# City of Alexandria, Virginia

## MEMORANDUM

**SUBJECT:** 2 DUKE STREET (ROBINSON TERMINAL SOUTH)  
SITE ELEMENTS AND HISTORIC INTERPRETATION WORK SESSION  
BAR CASE # 2015-0205

Figure 1. Historic shorelines as depicted in OLIN's June 2014 presentation to City Council.

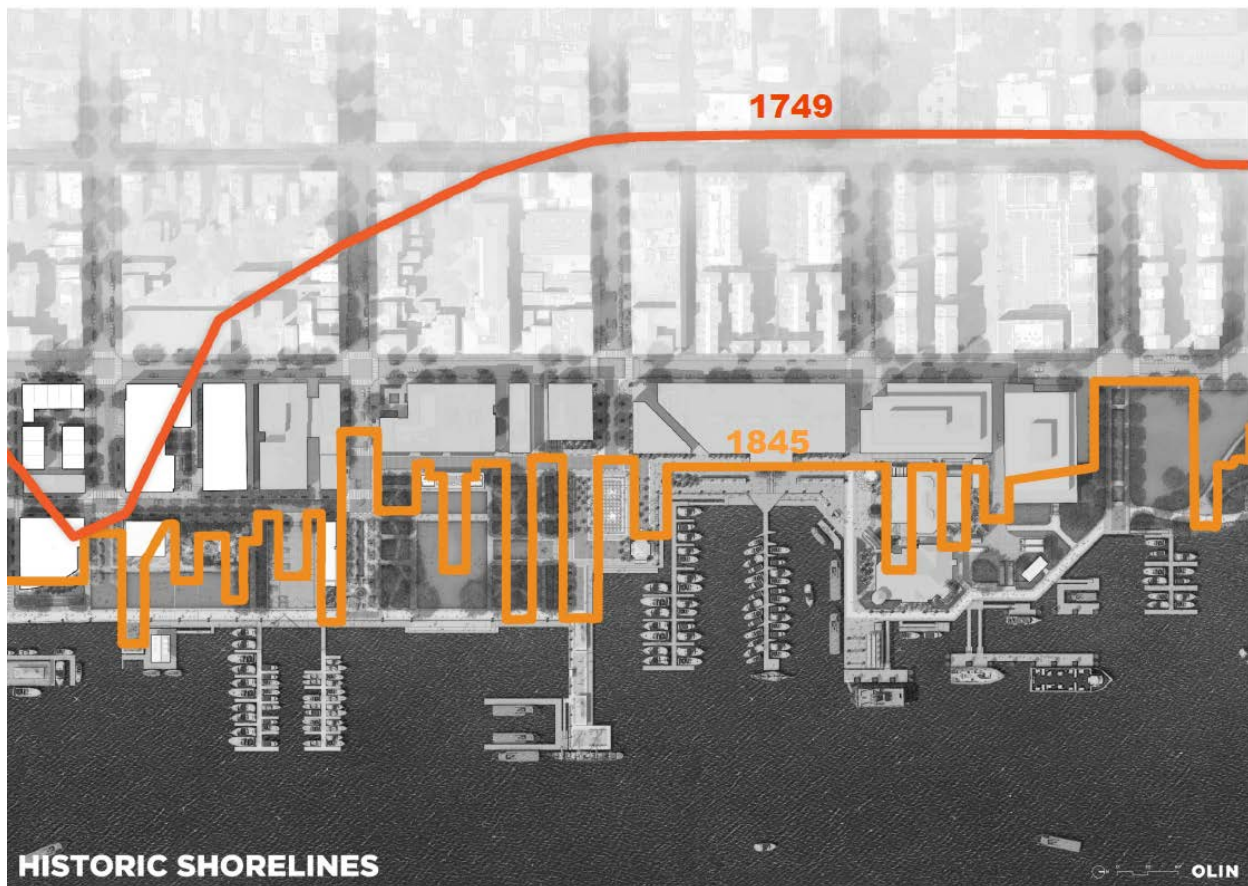
The presentation to City Council in June 2014 included a graphic depicting two historic waterfront features: the 1749 shoreline and the 1845 pier line (Figure 1). It is expected that both of these lines will be depicted continuously across the waterfront to show how the shoreline was extended out to the Potomac River channel in pursuit of industry and maritime commerce.

The applicant's proposal at the RTS site is to interpret both of these shorelines, as well as the 1877 pier line because that provides greater insight into the evolution of this particular block which had such a strong industrial history. While it might be too busy to interpret the 1877 pier line across the entire Waterfront Plan area, on the RTS site it provides a great snapshot into the complexity of the ever-changing edge of land and water as many different industries operated on this site over time. Therefore, staff supports the choice to add a third interpretive line here. It should be noted that the 1749 and 1845 delineation must be done in conformance with the overall depiction of these two elements across the plan area, utilizing a common material and vocabulary. The City is currently refining the material selection to delineate the different periods and the applicant will work with city staff and OLIN through this process.

**Figure 2. 1912 Building permit for RTS showing location of pair of railroad tracks on Union Street. Source: Alexandria Special Collections**

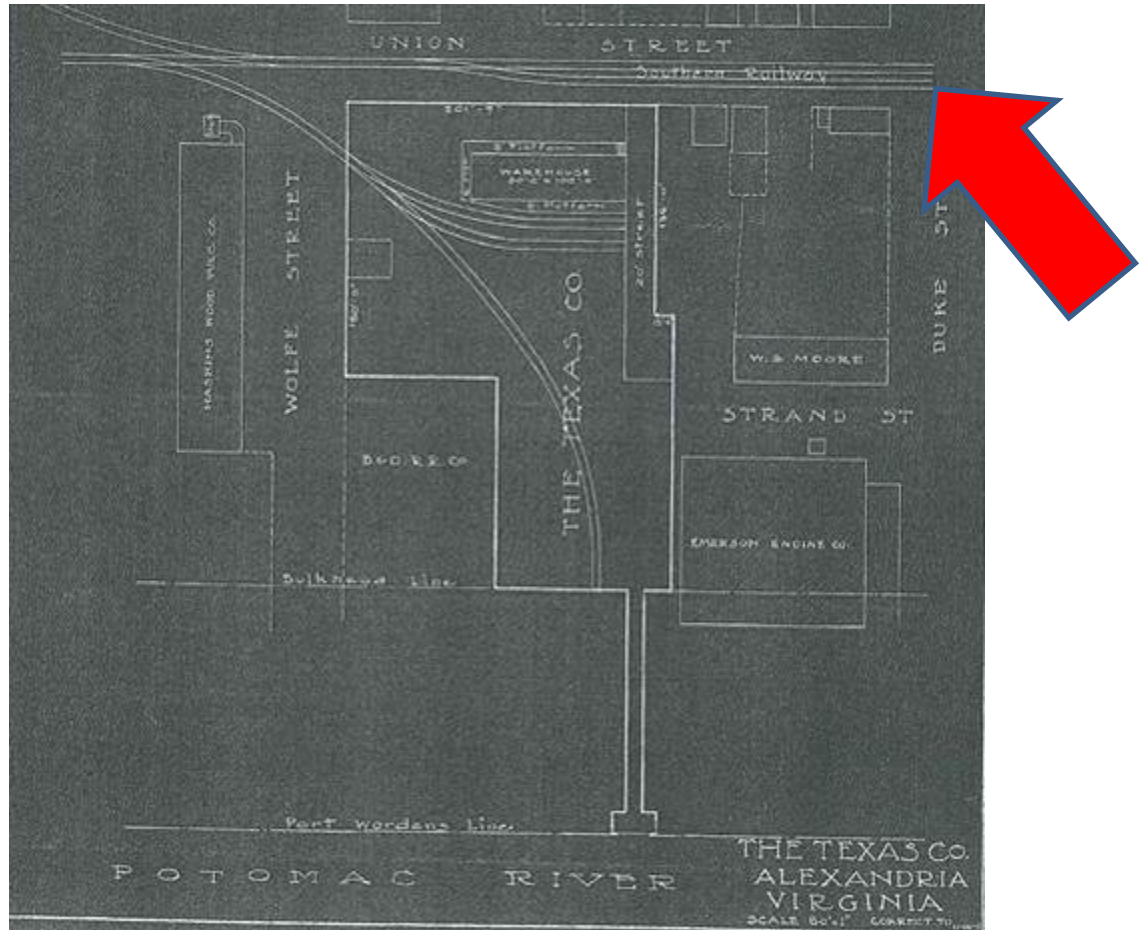
original rail line travelled down the middle of Union Street, by 1896 the Southern Railway constructed a second rail line to the east of the center rail line. The applicant proposes to interpret this second rail line in the approximately original location along the sidewalk at the western edge of the project site, with the anticipation that it might relate to a larger rail interpretation extending from the Wilke Street Tunnel. Staff finds that this element is an intriguing one that will be most successful if it can be incorporated beyond this site. This element also provides an interesting connection between the transport of goods from the waterfront over land.
